E4447A-04

**S E R V I C E N O T E**

E4447A - PSA Series Spectrum Analyzer

**Internal Alignment Failures for PSA Series Spectrum Analyzers Manufactured Between January 2004 and February 2006 Caused by Low Power Output from A9A1 DRO on A9 Second LO Assembly**

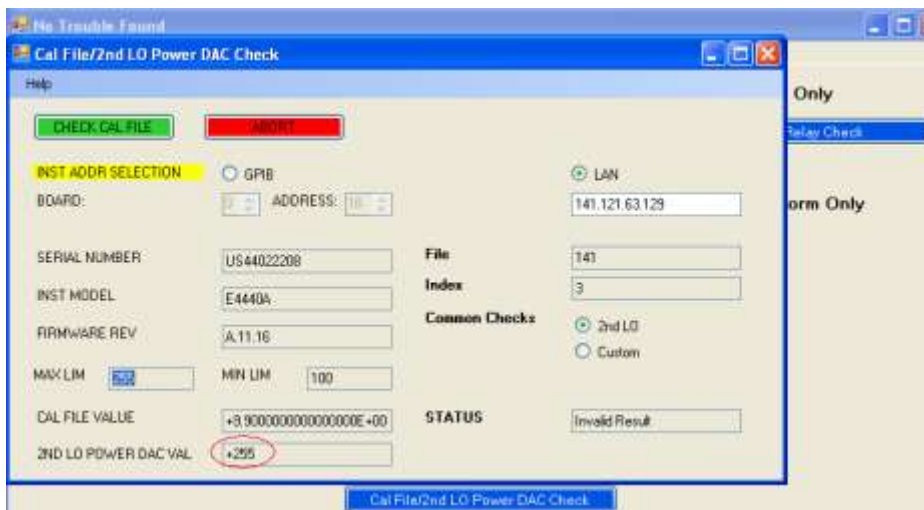
Verify the alignment failure by looking at the error queue for the error message “-340, Calibration failed, Align\_2<sup>ND</sup>\_LO\_PWR”. Press [System] <Show Errors> <Next Page>. Typically, when the Second LO power is too low, it will be the first failure listed in the alignment queue, which will be at the bottom the Second page of alignment errors (as shown below):

A value of +255 for the Second LO Power DAC Val will be returned if the analyzer is not able to set enough gain to the Second LO amplifier on the A20 low band assembly if the DRO power output is too low. The lower the DAC value reported is, the more gain the low band amplifier is using. When the low band amplifier is no longer able to provide enough gain, the DAC value rolls from 0 (most gain) to 255 (least gain), causing the internal alignments to fail.

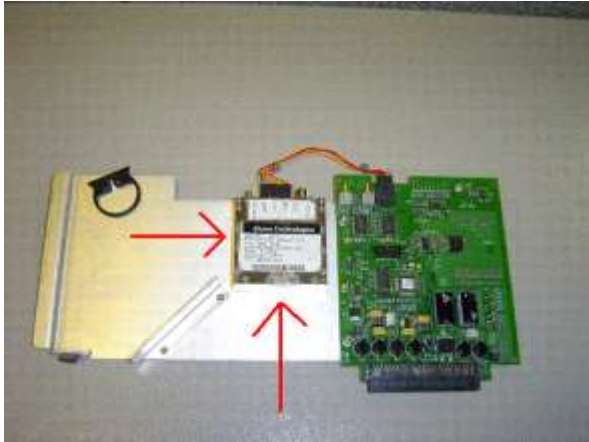
The failure can further be verified by directly measuring the power output from the A9A1 DRO on the A9 Second LO assembly. The instrument cover and top brace must be removed and the instrument powered up. The W15 cable connected to the Second LO must first be disconnected. Either a spectrum analyzer or power meter can be connected to the 3.6 GHz output of the Second LO to measure the power output level. New DRO's typically output +1 to +3 dBm of power; however, any output power above -2 dBm is normal. Whenever the power output is less than -5 dBm, the DRO is bad, and the amplifier on the A20 low band assembly is no longer able to compensate.

Replace just the DRO by removing it from the Second LO assembly and replacing it with a new one.

No adjustments are needed, since the Second LO Power Adjustment routine in the TME calibration software is only necessary to be run when the A20 low band assembly is replaced and not when the DRO or Second LO assembly is replaced.
